# Product Bulletin

Issue no. 26 / January 09

## PM Information: 500 Series Rotor Bearing Improvements

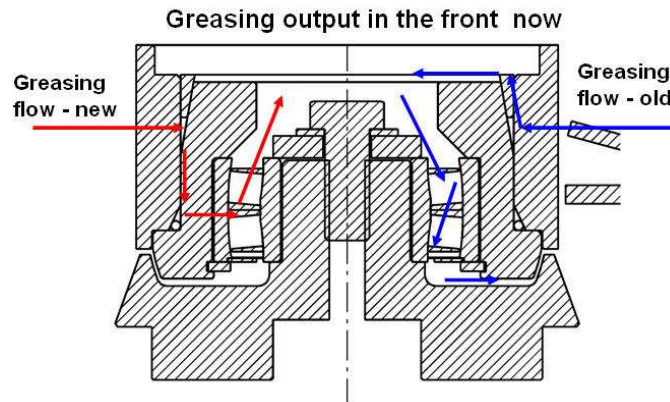
For the new rotor bearing CLAAS Engineers redesigned the flow of grease into the bearing as shown in the drawing below.

CLAAS Kit number 173 630.3
